Project: BW2098POE
Current Revision: R2M1E2

BW2098POE Revision History:

Title BW2098POE			Luxonis Holding 1925 Harmony Park Drive Westminster, CO 80234	LUX onis
Size: Tabloid	Number: D2098000	Revision: R2M1E2		
Date: 7/23/2020	Time: 3:20:29 PM	Sheet 12 of 12		
Drawn by: Brian Weinstein			United States

LED INDICATORS

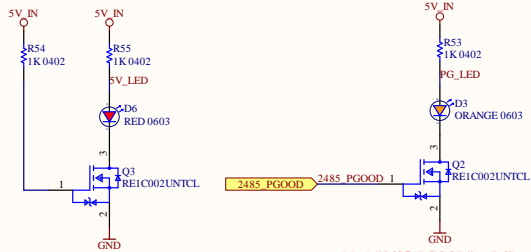
Date	Revision	Reason for Change	Changes Implemented
3/4/2020	Initial Release -> ROM0E0		
5/29/2020	ROM0E0 --> R1M1E1	1) Pull up the EN pin on the 3.3V regulator 2) R1 should be depopulated (PU for MA2485 WAKEUP line) 3) Add ESD protection diodes to the Ethernet lines 4) LEDs labels for "hRST" and "5V" are switched. 5) Polygon 3V3_L01_P425 is underneath GND polygon on Layer 1 and didn't pour correctly (still electrically connected by tracing). 6) J5/J8 are a bit too close for both cable housings 7) RGB camera connector tab hard to get to as it's under the BW2099 8) Label the boot switches 9) KingTop doesn't like the L1 inductor. Says it's too fragile and hard to handle. Try to find alternate.	1) 3.3V regulator EN pin pulled high to 5V 2) Depopulated R1 on Production variant 3) Added pads for ESD protection diodes on ethernet diff pairs 4) Swapped "hRST" and "5V" labels on overlay and added netnames to LEDs in schematic to help prevent this in the future. 5) Removed polygon and thickened traces 6) Increased connector spacing by 50mils to allow clearance 7) Moved connector 2mm right to make it a bit easier to grab the latch. Still not great, but better. 8) Added overlay labeling for each BOOT(4:0) and GPIO58 9) Moved the L1 inductor to L1 on layout so it wasn't so exposed to impacts. Did not change PN or schematic.

Mark "5V" on PCB
